**SOUTHERN CALIFORNIA GAS COMPANY (SOCALGAS)
SIERRA CLUB-SCG-05
WOODY BIOMASS PILOT PROJECT APPLICATION (A.25-10-008)
DATE REQUESTED: February 25, 2026
RESPONSE DUE: March 11, 2026**

In SoCalGas’s response 2-14 to Sierra Club’s Second Data Request, SoCalGas states that, “CO2 in the flue stream will also be captured, labeled ‘exhaust’ in Lane 2 of the Process Flow Diagram. There are supplier technologies being considered that separate the CO2 from this stream including adsorption and filtration.”

WBF Process Flow Diagram (Submitted for Cal Advocates DR-01 Question 4)

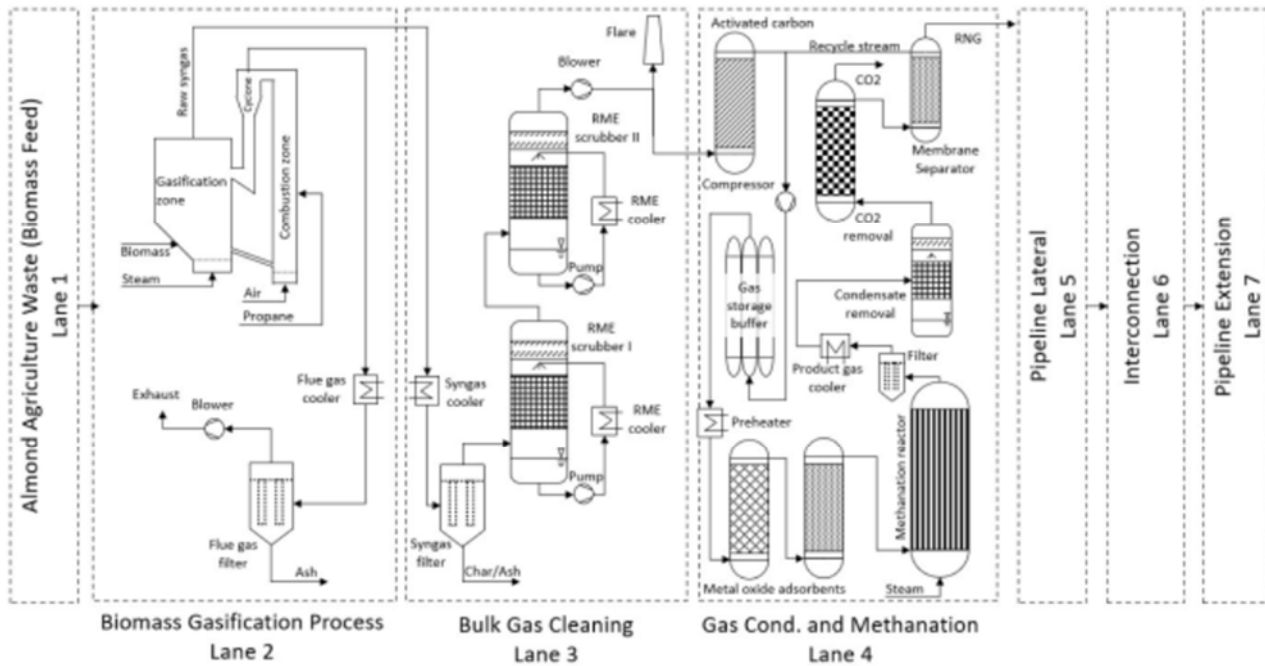
What “supplier technologies” are being considered?

Adsorption and filtration are the technologies being considered.
